Subject: RE: 22 Beach Road, Littlehampton.

Thank you for your report, Issue 1, dated 20th September 2019 in respect of Project Number J2707, (as attached), which was amended in the light of my previous comments and my E Mail 4th September 2019, as below.

I can confirm that I agree the contents of this report and have no objection to discharge of the relevant Condition 4 (LU/321/17/PL) on this basis. Given that this report also examines the effect of flue noise on these flats which was found to be acceptable, then I also agree to discharge of Condition 3 in respect of LU/56/17/PL.

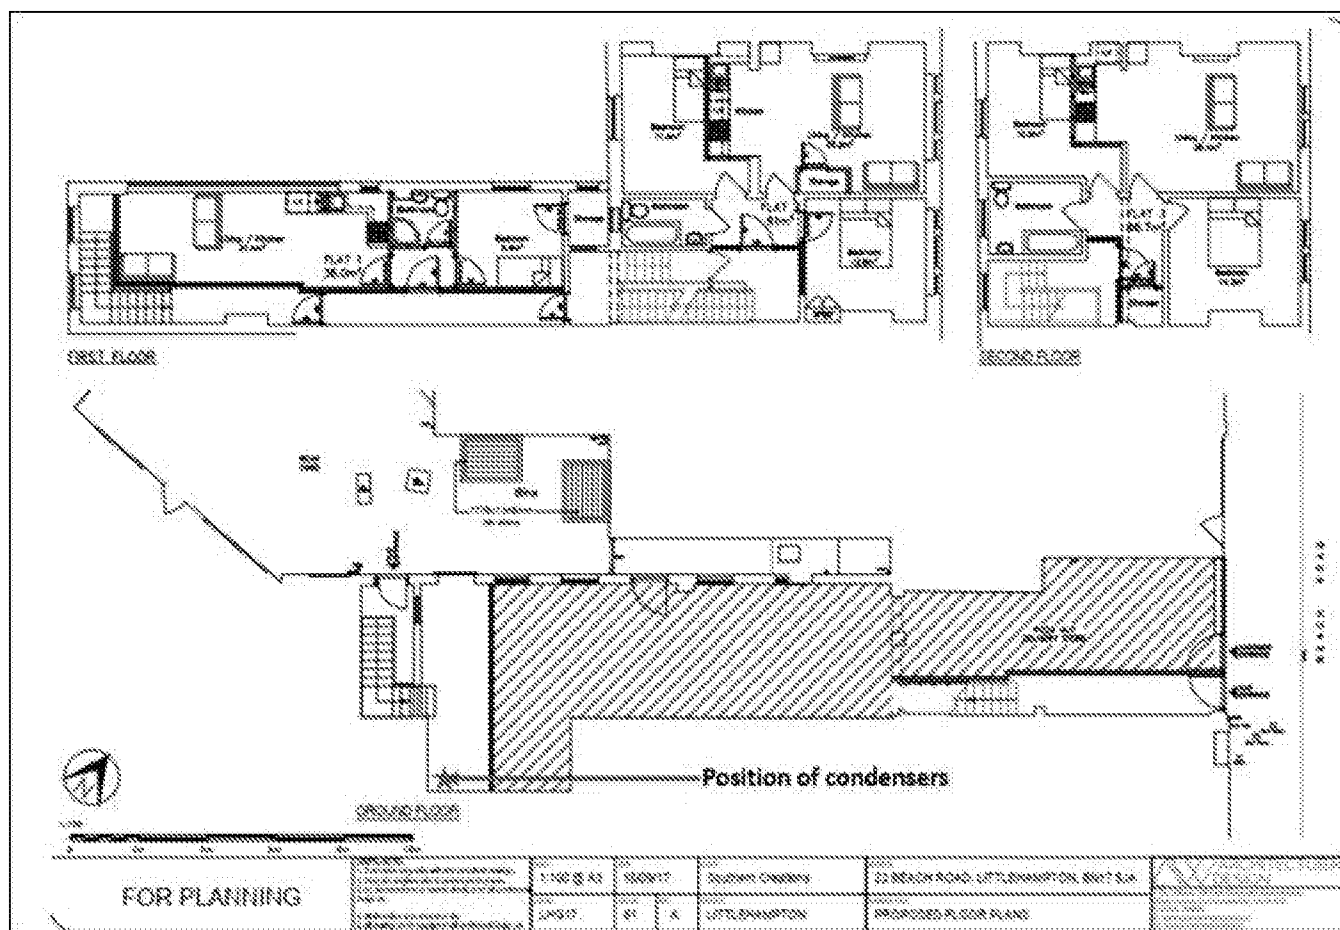
1. The condenser unit for the Walk in chiller.

The condensers were previously located below the bedroom window but have since been relocated to inside the rear garage unit at the very rear of Flat 1, outside the demise of the flat.

The condensers are mounted on anti-vibration mounts on the ground floor. Both the garage and the pizza hut ceiling were soundproofed at the same time. The condenser positions inside the garage void are shown below.
